# Westlink Industrial Estate Stage 1 Modification 3

State Significant Development Modification Assessment Report (SSD-9138102-Mod-3)

April 2024

**Figure 5 | Proposed roof plan for Warehouse 1**

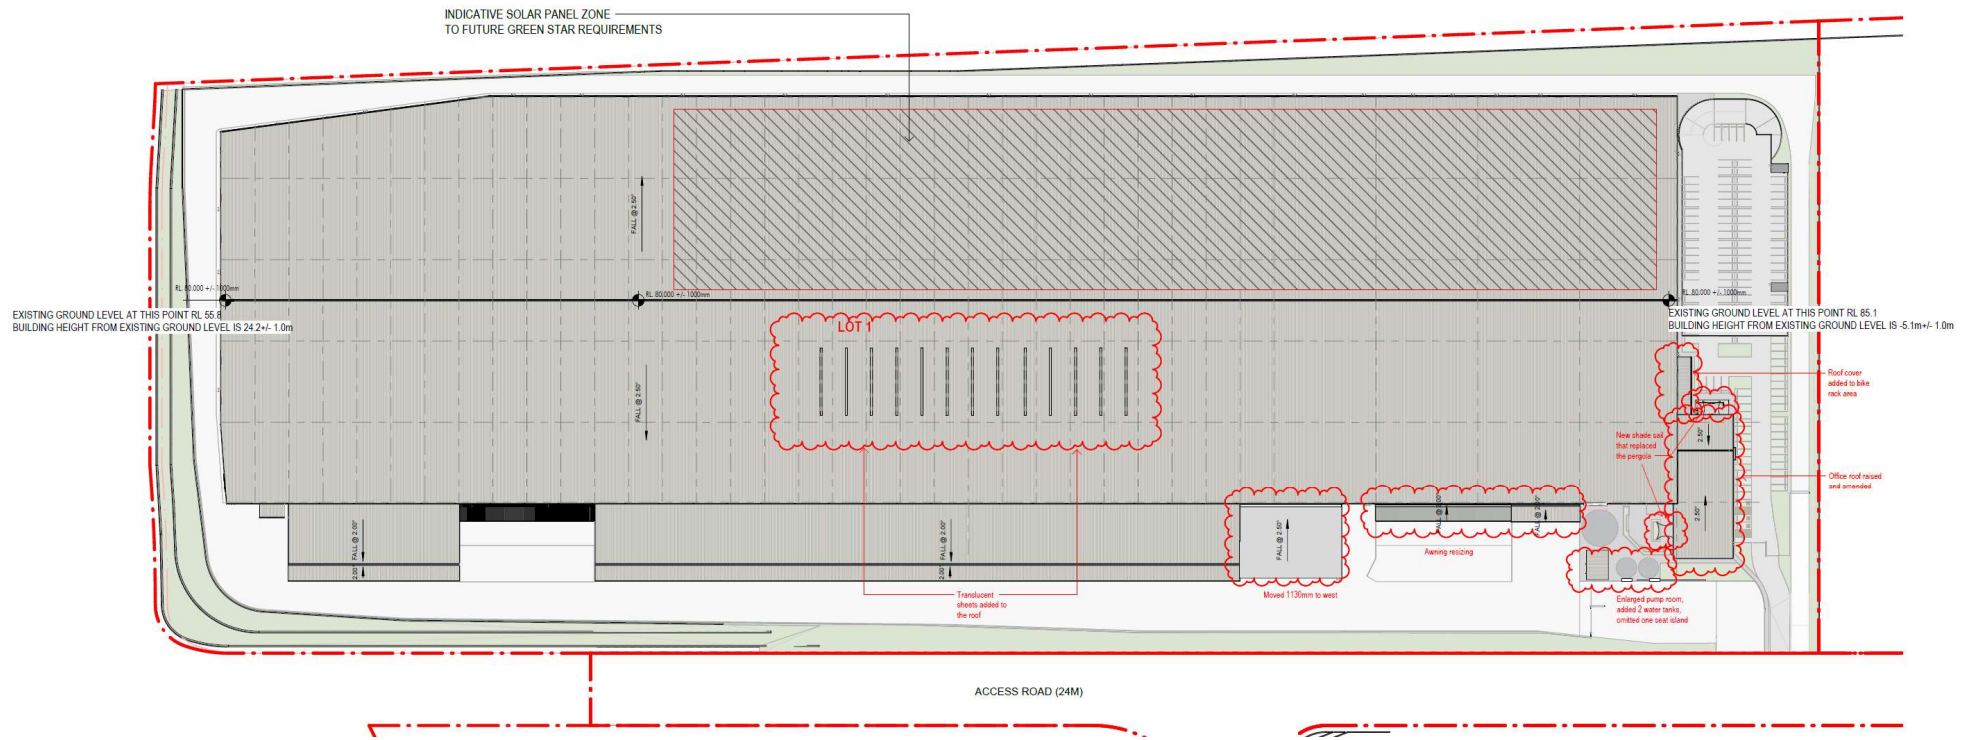
The modification seeks to make minor changes to the approved design for Warehouse 1 to reflect tenant requirements, including:

- relocation of the battery charging room and recess docks approximately 1 m to the west
- relocation of the north-eastern rainwater tank to underground below the hardstand near the transport office

- addition of extra windows to the transport office
- enlargement of the pump room and addition of two water tanks
- reconfiguration of the southern recreation area and replacement of approved pergolas with shade sails for the outdoor area

- reconfiguration of the warehouse amenities in the south-west corner of the site
- addition and relocation of fire egress doors
- adjustments to the internal office layout, including a new awning over the entry, and removal of external stairs

- warehouse office roof amended and raised by 250 millimetres (mm)
- reduction in car parking provision by six spaces
- addition of translucent sheeting to the warehouse roof

- changes to the sizing of the awning above the recessed docks adjoining the battery charging room, and
- minor reconfiguration of the driveway, with a sliding gate instead of swing gates, and landscaping at the entry to the site.

Figure 6 | Proposed east and west elevations for Warehouse 1

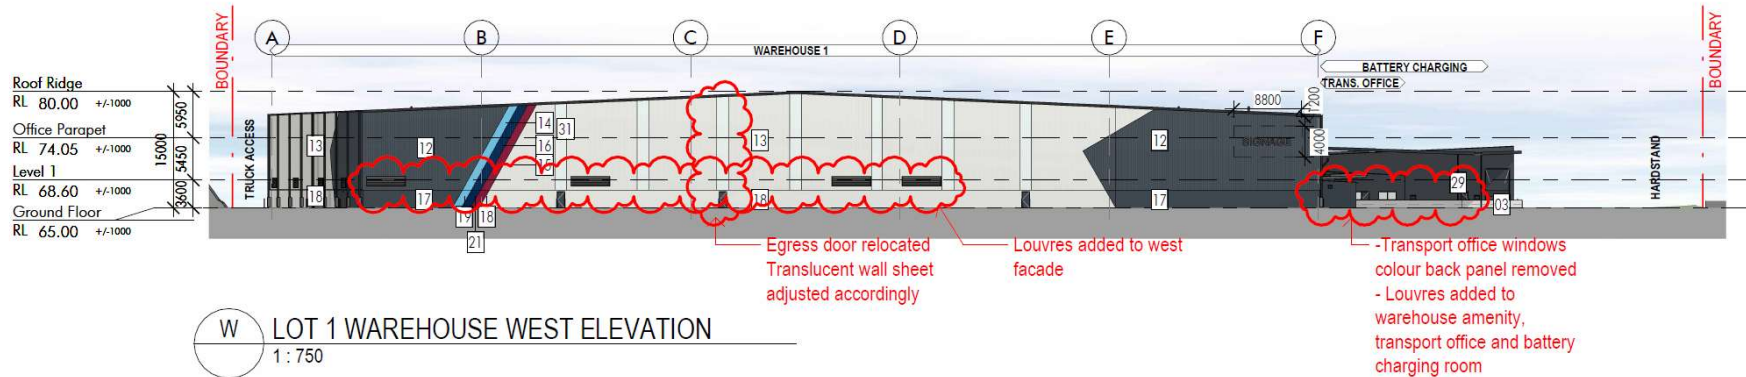
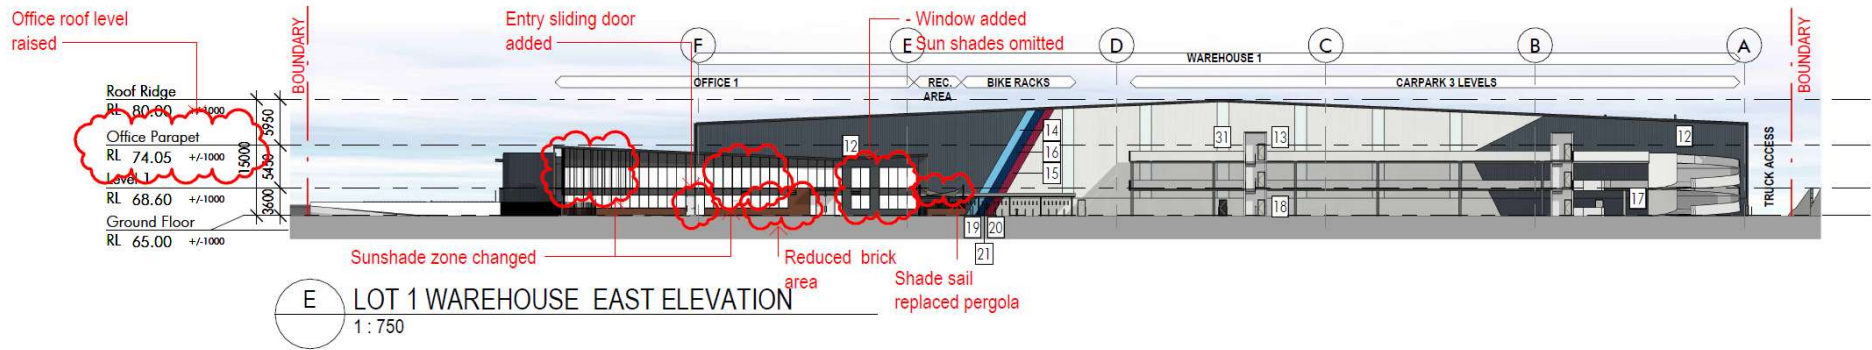
- justification for the inclusion of the louvres on the elevations of the Lot 1 warehouse and clarification on whether this addition will impact on potential noise impacts from the development
- details on the screening of the proposed additional water tanks to improve visual presentation from the road
- details on the calculations relating to the pervious shortcrete surfaces to the areas along the northern boundary of Lot 1 as part of the retaining wall design.

<ul style="list-style-type: none"> <li>The modification proposal includes addition of louvres to the transport office, battery charging station façade and north façade at Warehouse 1.</li> <li>Through the RFI, the Department requested for the Applicant to clarify whether the proposed additions would impact on noise emissions from the development, or any assumptions previously assessed for the approved development.</li> <li>The Applicant justified that the proposed louvres are located on the western and northern elevations of Warehouse 1 facing land zoned IN1 General Industrial and are not anticipated to impact noise to surrounding sensitive receivers (Luddenham/ Mount Vernon residents and BAPS Swaminarayan Sanstha Temple) as identified in Condition B52 of the SSD-9138102 consent.</li> <li>The Applicant further stated that previous noise technical reports provided for the assessment of the approved development had demonstrated that potential noise impacts from the site were more likely associated with external noises sources such as vehicle movements rather than the building operations. Based on this, the location of the proposed louvres would not contribute to any additional impacts on the noise modelling previously undertaken for the approved development.</li> <li>The Department considers that the potential noise emissions associated with the additional louvres added to the Warehouse 1 building façade would be negligible, and that the modification will not likely contribute to further noise impacts from the approved development. Noting that the SSD-9138102 consent requires adherence of specific noise limits and the</li> </ul>	<p>No additional conditions recommended.</p>

- justification on the proposed relocation of the louvers on the Lot 1 warehouse due to potential Bushfire Attack Level (BAL) mapping in relation to bushfire protection, and confirmation that the changes to their location would not impact the previous noise impact assessment for the development as external noise sources (e.g., truck movements) would be greater
